IEEE 802.3cg

10BASE-T1S Autoneg and Link Status Indication

October 24th, 2018

Figure 147-4 PCS Transmit state diagram (part a)

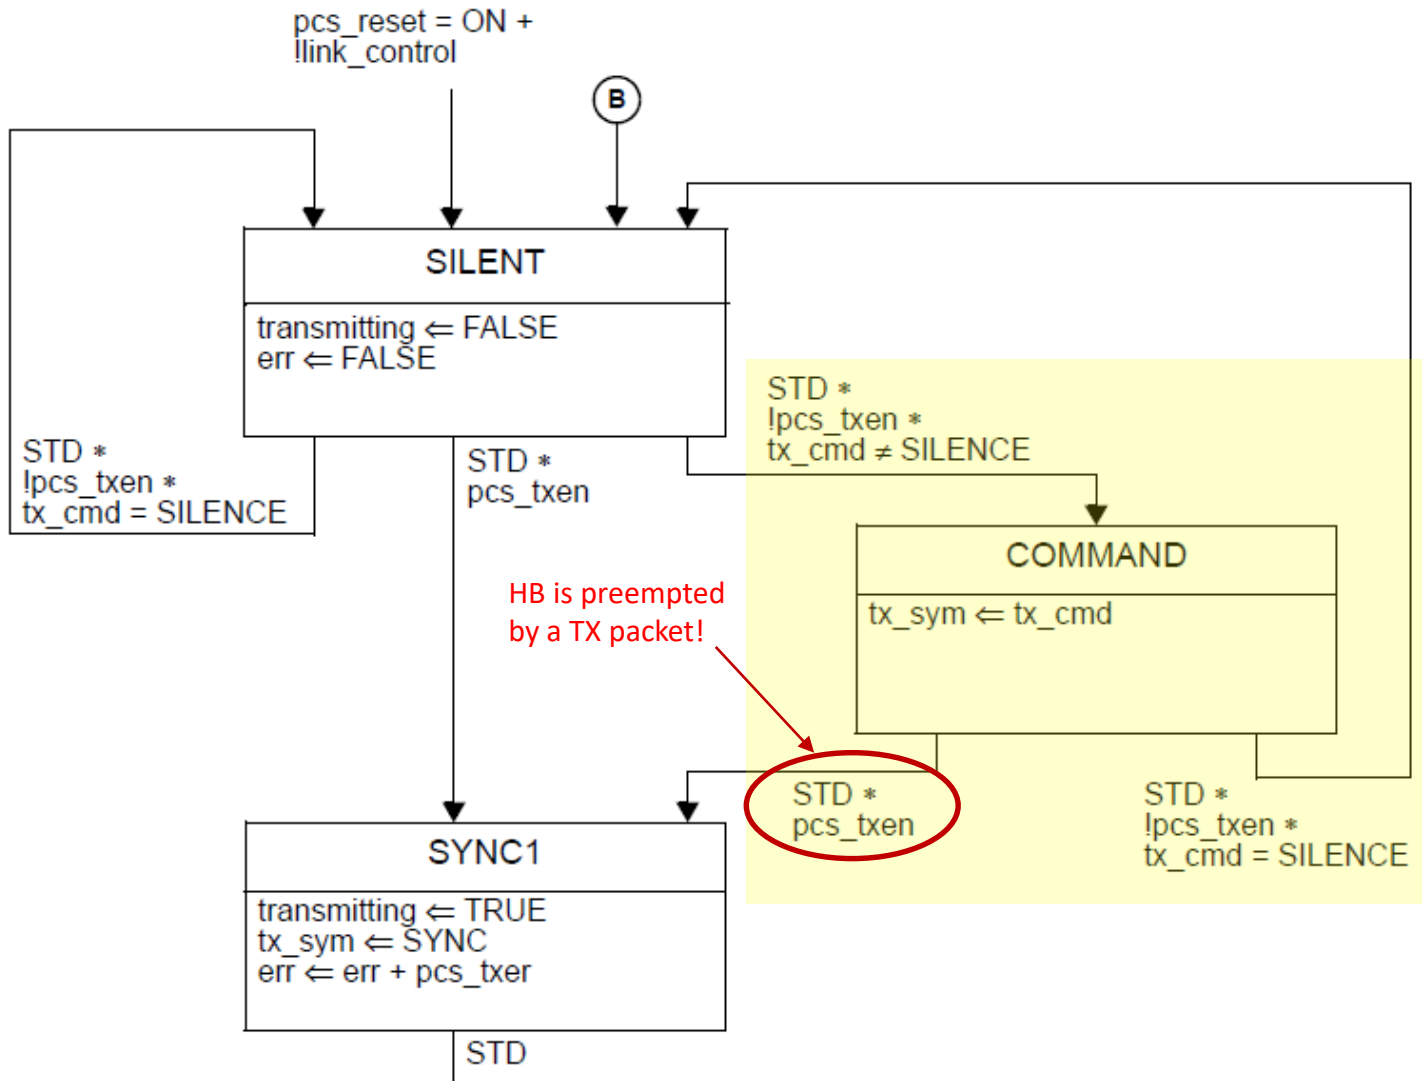
Not interfering with TX from MII: re-use of PCS TX COMMAND state to send HB on the line

HEARTBEAT is a repeated 'T' (01101) 5B symbol. Such symbol is already used as ESD but it can be re-used for this purpose (no ambiguities)

It is transmitted by PCS TX, using the already available `tx_cmd` variable.

The `tx_cmd` variable is used by PLCA RS to convey BEACON and COMMIT commands to the PHY. PLCA takes precedence over the HB.

Figure 147-3—PCS reference diagram

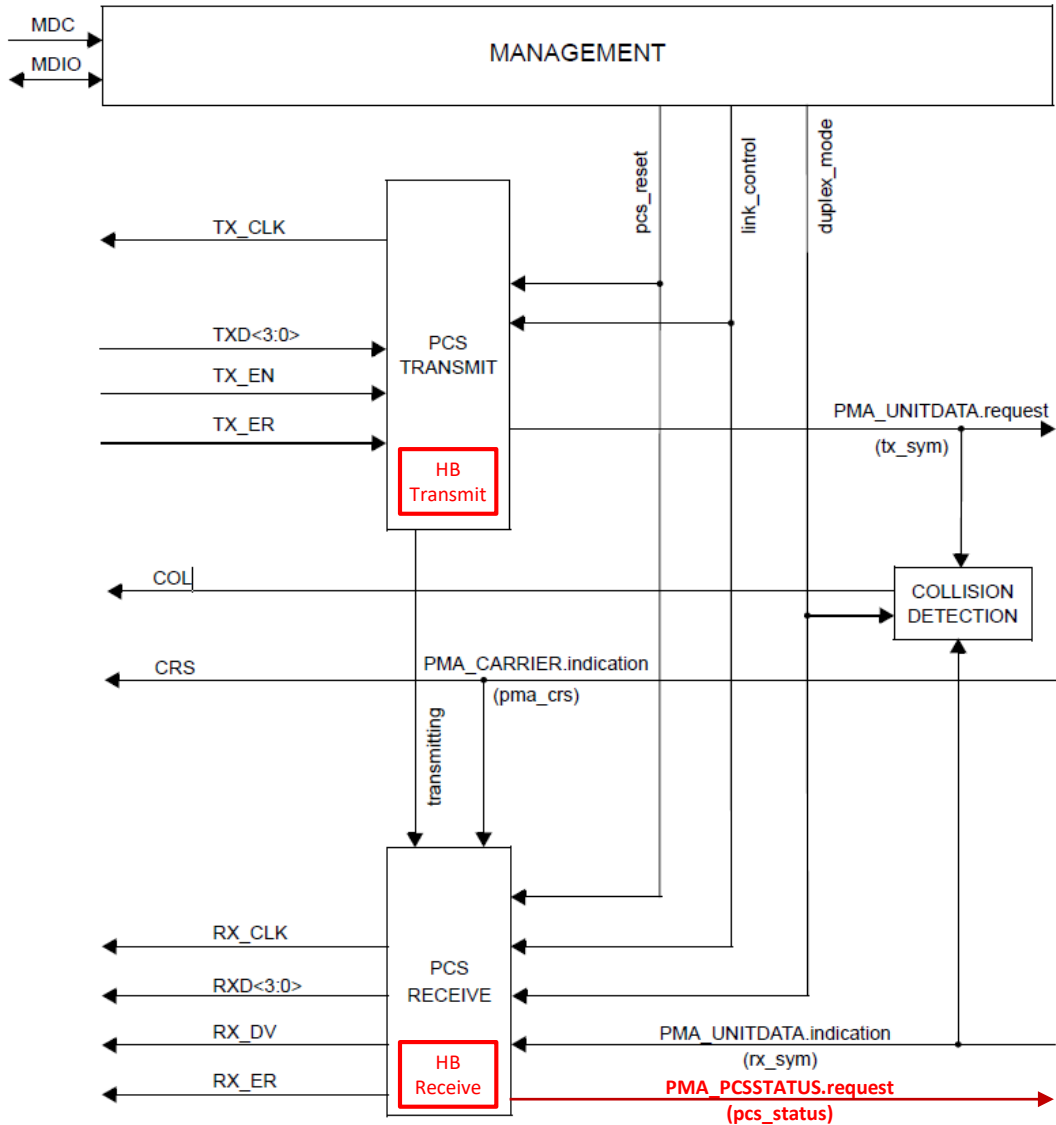
Modifications to PCS / PMA (add PMA primitives)

HB Transmit State Diagram 1/2

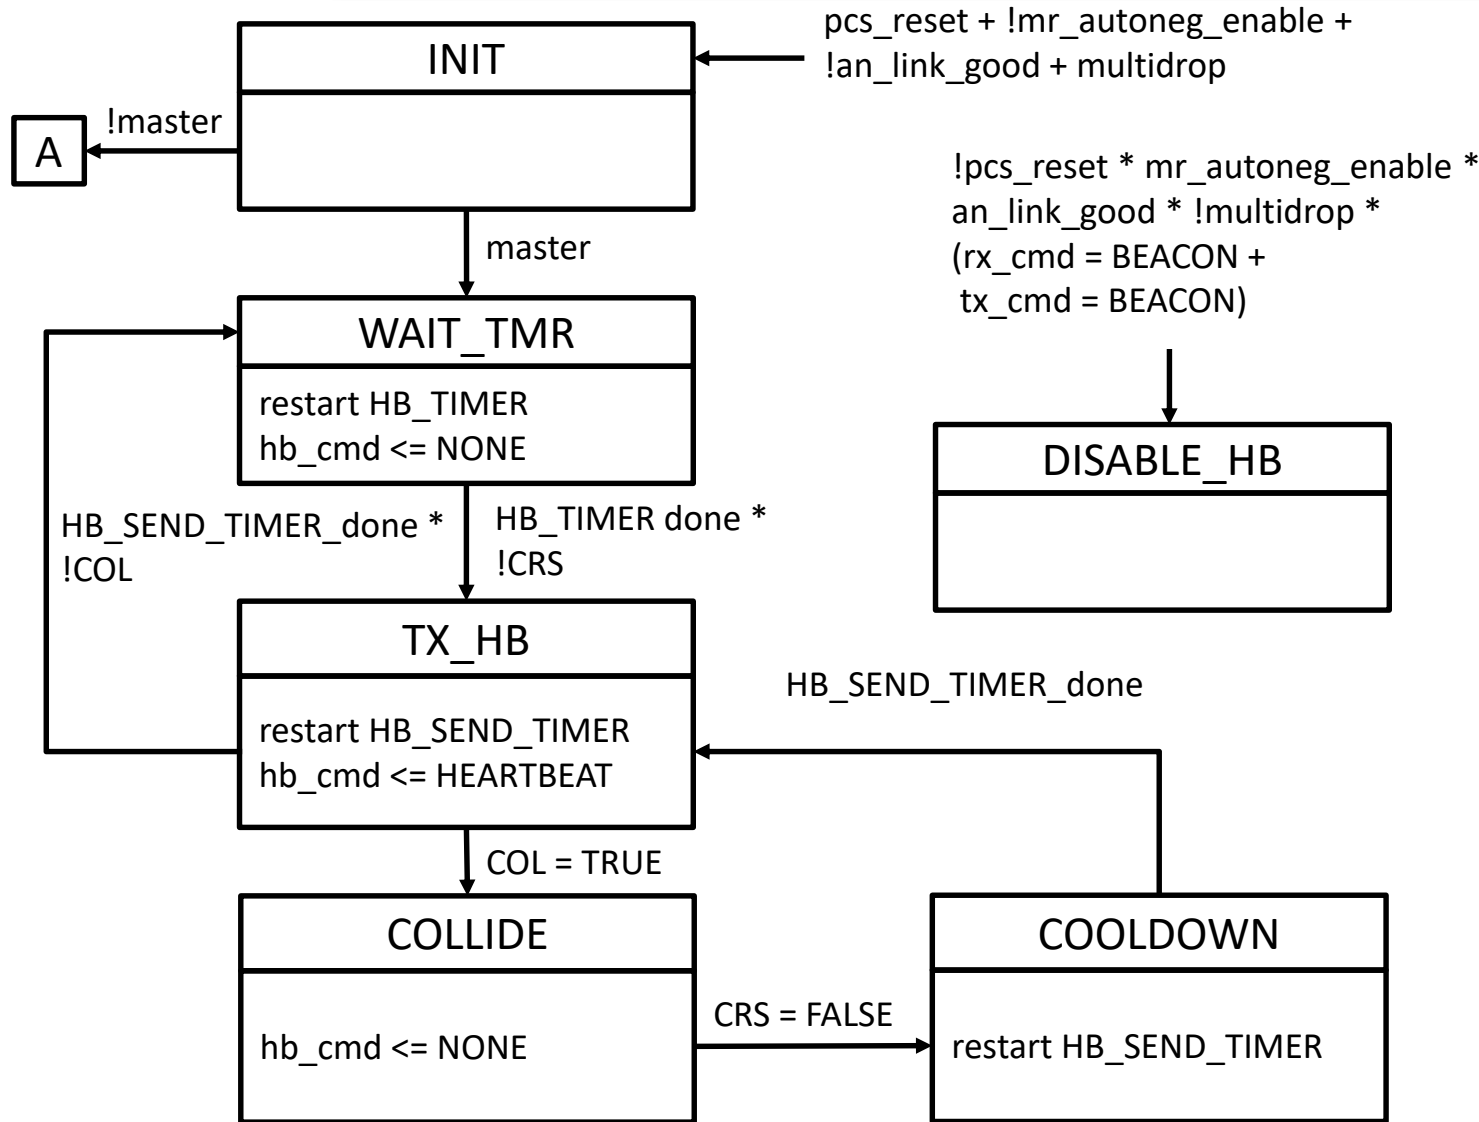
- **HB_TIMER = 50 ms**
- **HB_SEND_TIMER = duration of HB on the line = 20 bit-times**
- **mr_autoneg_enable = Auto-Negotiation supported and enabled**
- **an_link_good = Auto-Negotiation complete**
- **multidrop = Multidrop mode (register 1.2299.10)**
- **master = TRUE** when master role negotiated using method in 98.2.1.5 and Table 98-4
- **rx_cmd = enumerated value set to 'BEACON'** when a BEACON indication is generated as specified in 147.3.7.1. Set to 'COMMIT' when a COMMIT indication is generated as specified in 147.3.7.2. Set to 'HEARTBEAT' when a HB is detected on the line. Set to 'NONE' otherwise.

HB Transmit State Diagram 2/2

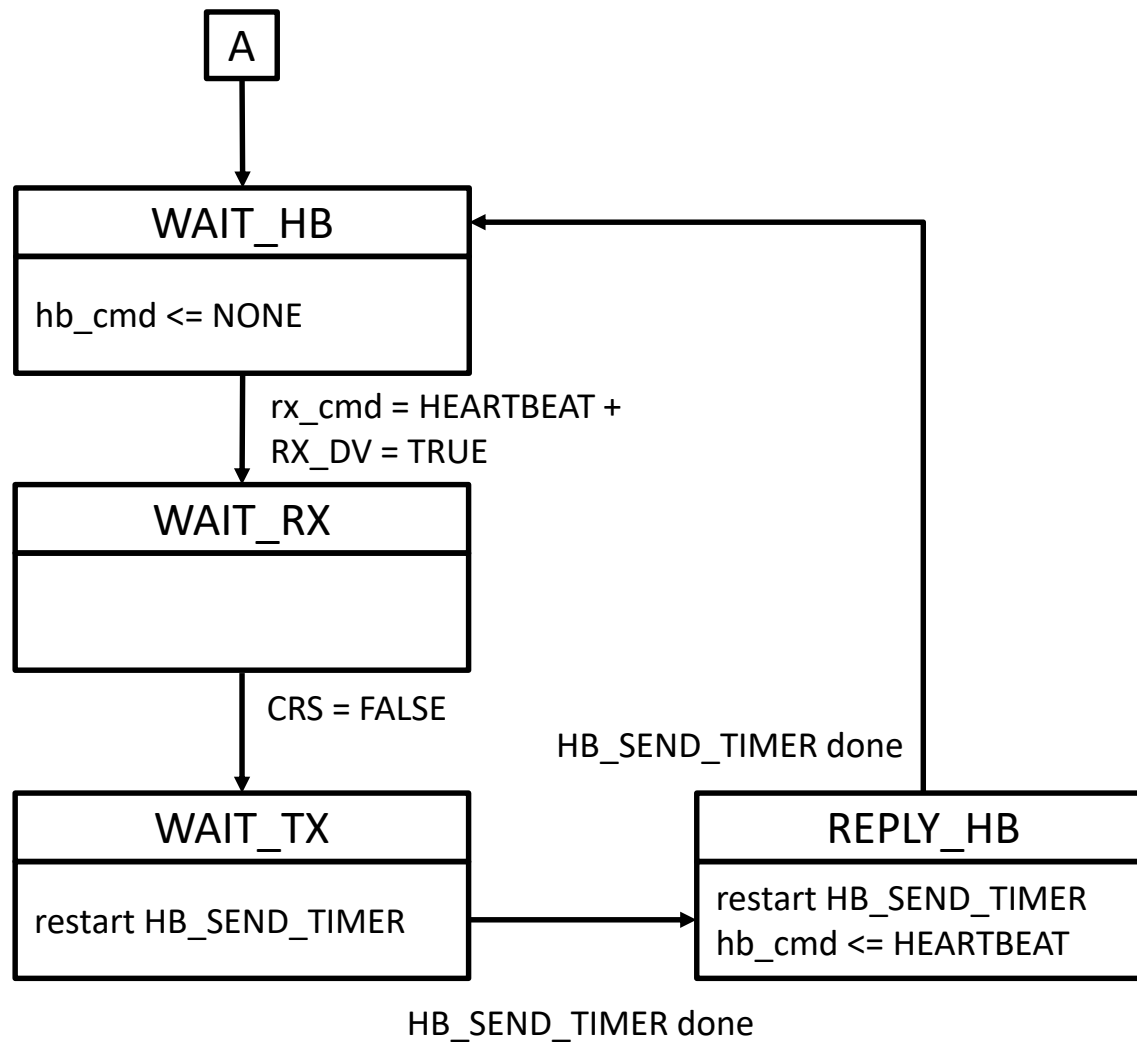
- `HB_SEND_TIMER` = duration of HB on the line = 20 bit-times
- `mr_autoneg_enable` = Auto-Negotiation supported and enabled
- `an_link_good` = Auto-Negotiation complete
- `multidrop` = Multidrop mode (register 1.2299.10)
- `hb_cmd` = enumerated value. Values: HEARTBEAT, NONE.

HB Receive State Diagram

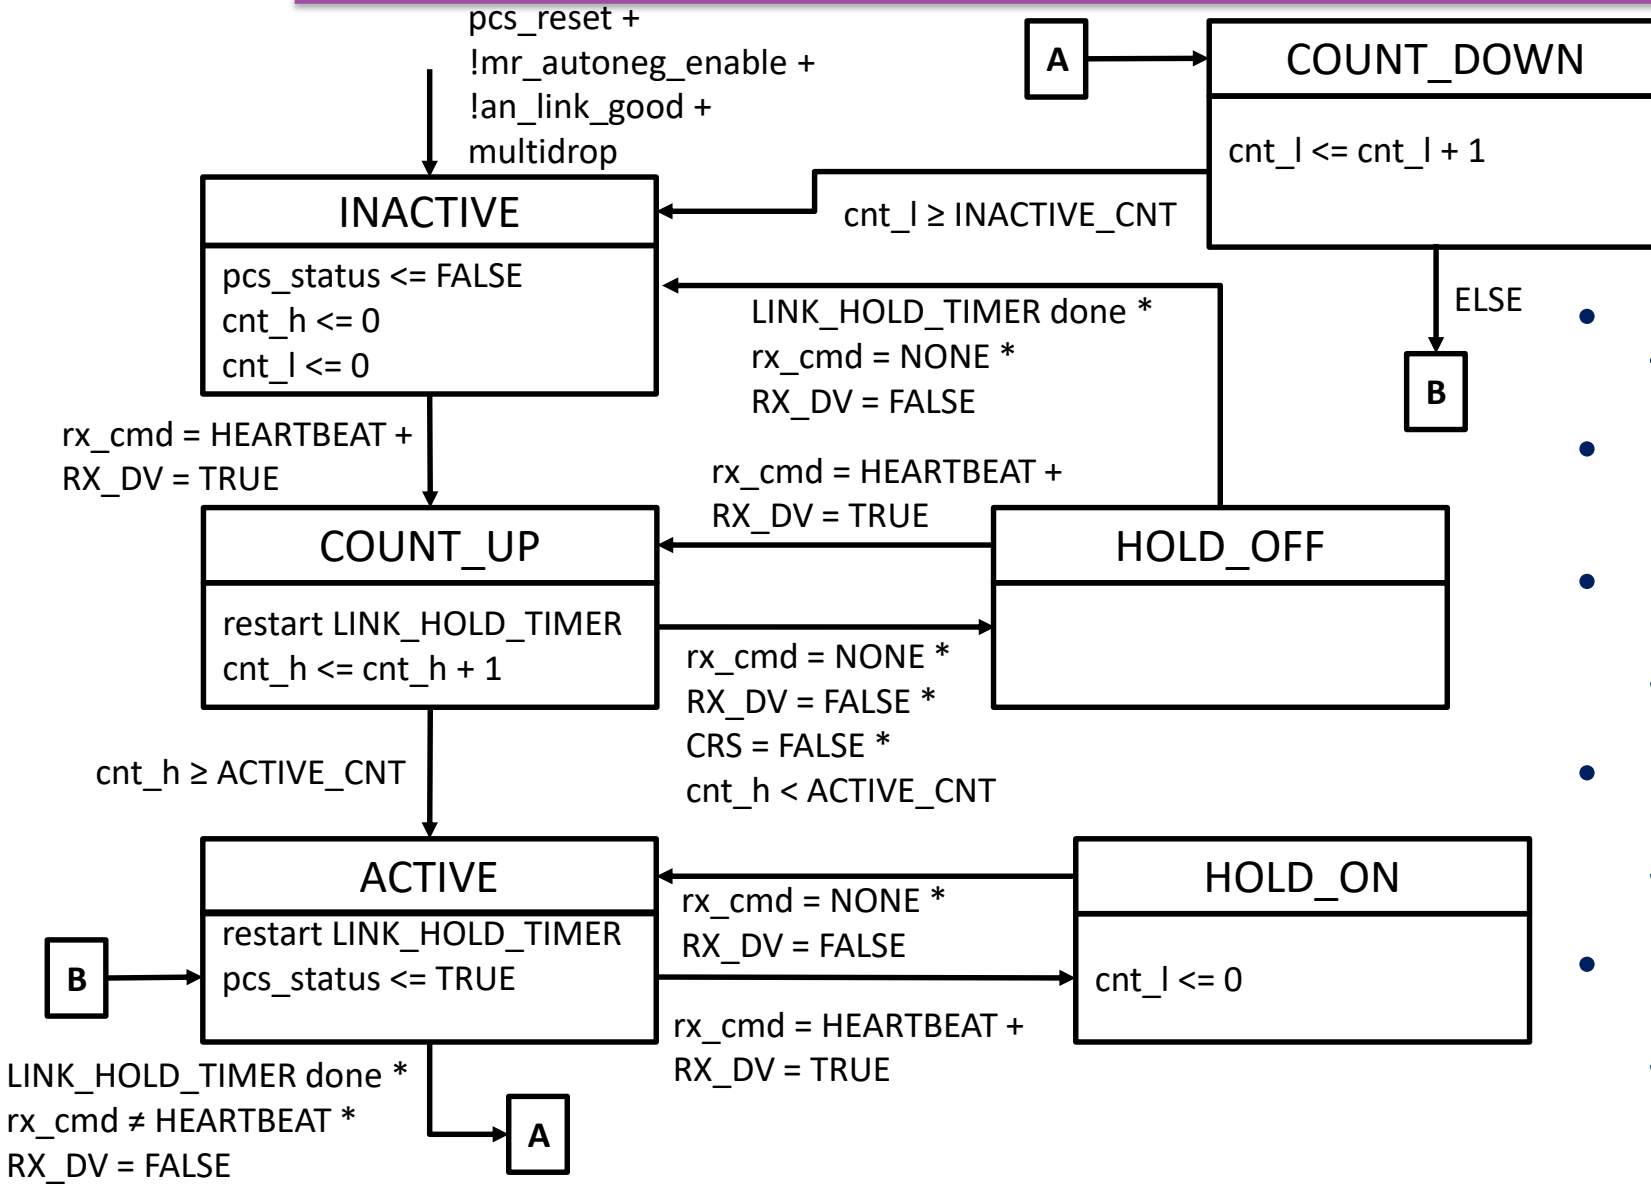
- `cnt_l` = counter of HB when `pcs_status` is TRUE
- `cnt_h` = counter of HB when `pcs_status` is FALSE
- `ACTIVE_CNT` = number of HB required to signal `pcs_status = TRUE`
Value: 1
- `INACTIVE_CNT` = number of HB required to signal `pcs_status = FALSE`
Value: 5
- `LINK_HOLD_TIMER`: time after which the count of HB is reset
Value: 50 ms

- `tx_cmd`
 - 5B symbol to be transmitted when the PCS Transmit function is in COMMAND state. The `tx_cmd` variable is assigned according to PLCA RS signaling over MII interface, as defined in 22.2.2.4, 148.4.3.1.1, and 148.4.3.1.2. It is also set according to the value of the `hb_cmd` variable, defined in 147.x.x.x. The following mapping shall be used:
 - `tx_cmd` \leq 'N' when a BEACON request is asserted
 - `tx_cmd` \leq 'J' when a COMMIT request is asserted
 - `tx_cmd` \leq 'T' when `hb_cmd` variable is set to HEARTBEAT and none of the previous requests is asserted.
 - `tx_cmd` \leq 'I' otherwise.

Link Monitor State Diagram

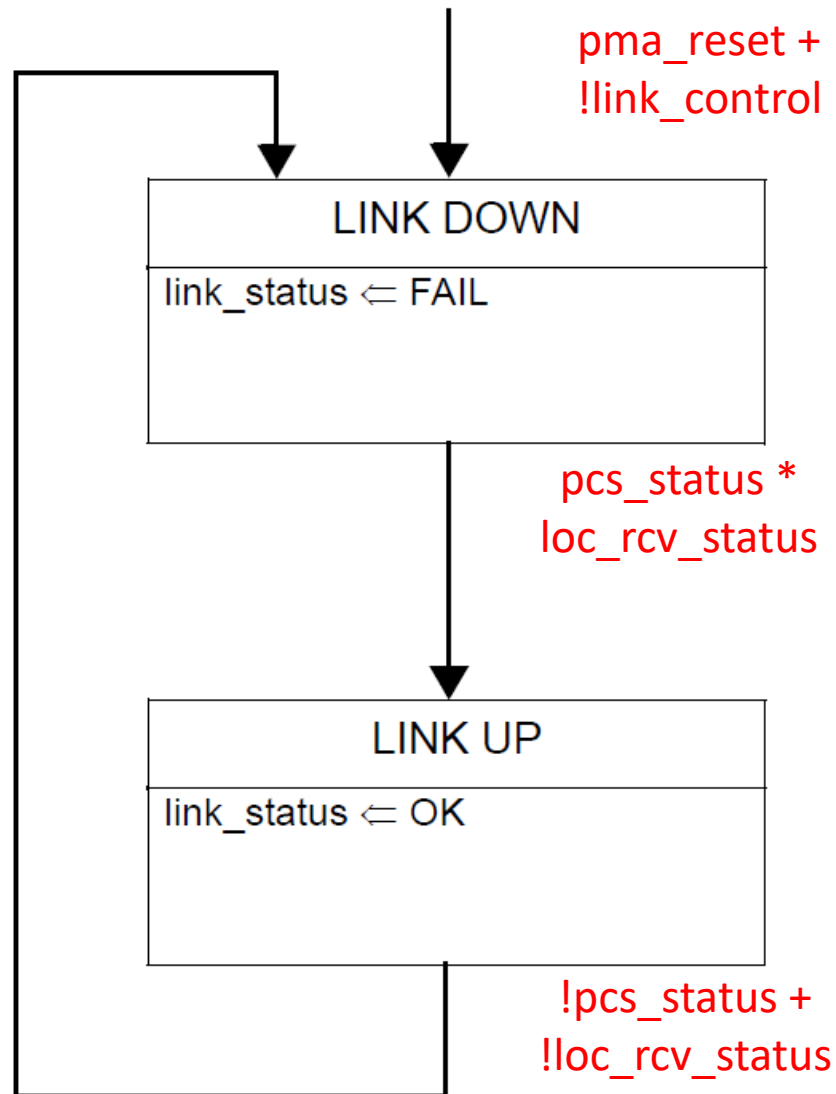
- `link_control`: generated by management
- `pcs_status`: conveyed by PCS via the `PMA_PCSSTATUS.request` primitive
- `loc_rcv_status`: implementation defined variable, indicating the PMA is ready to receive data from the line
- `link_status`: parameter of the generated `PMA_LINK.indication` primitive
